Item Name: Crosstube Turning Detail

DART AEROSPACE LTD		Work Order: 85830
Description: Crosstube Assembly (205/212/412 High Fwd)		Part Number: D212-664-141
Inspection Dwg: D212-664-141 Rev: D		Page 1 of 2

DRAWING NO. D212-664-141	TITLE XTUBE ASSY (205/212/412 HI FWD)	REV. D	DART AEROSPACE LTD ENGINEERING ORDER		D.E.O. NO. D212-664-141-D-1	SHEET NO. SHEET 1 OF 2	SCALE NTS
DRAWN	CHECKED	MFG. APPR.	APPROVED	DE APPR.			
DATE 11.04.07	DATE 11.04.11	DATE 11.04.12	DATE 11/04/12	DATE 11.04.12

ADD AN INSPECTION WINDOW TO UNDERSIDE OF CROSSTUBE.

**D212-664-141/-141B
ASSEMBLY DETAIL**

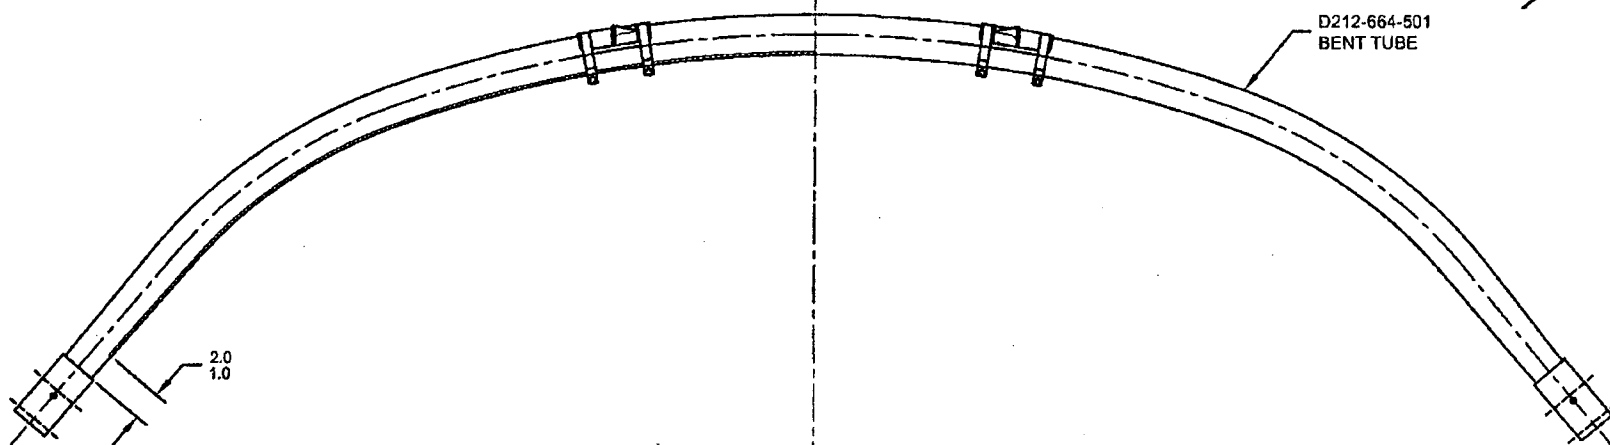
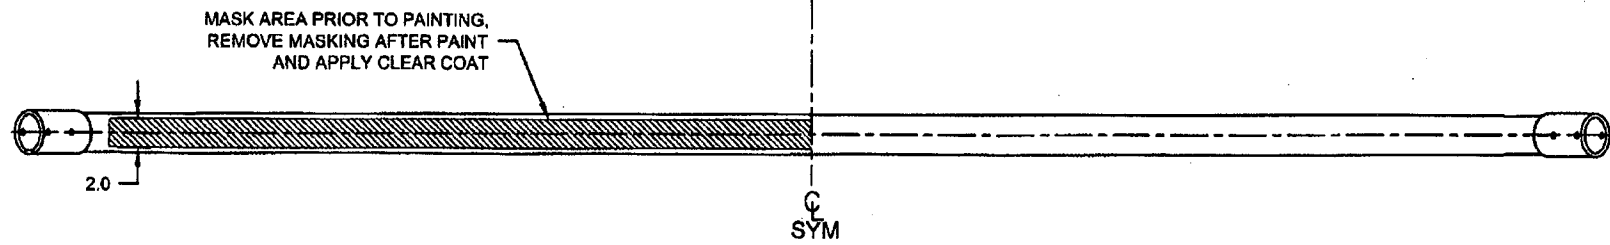
NOTES 2 OF SHEET 1 IS AMENDED AS FOLLOWS:

- 2) FINISH: CHEMICAL CONVERSION COAT PER DART QSI 005 4.1
PRIME INSIDE AND OUTSIDE PER DART QSI 005 4.2
MASK UNDERSIDE OF CROSSTUBE AS SHOWN (HATCHED AREA) AND
PAINT OUTSIDE PER DART QSI 005 4.2
REMOVE MASKING AND APPLY CLEAR COAT
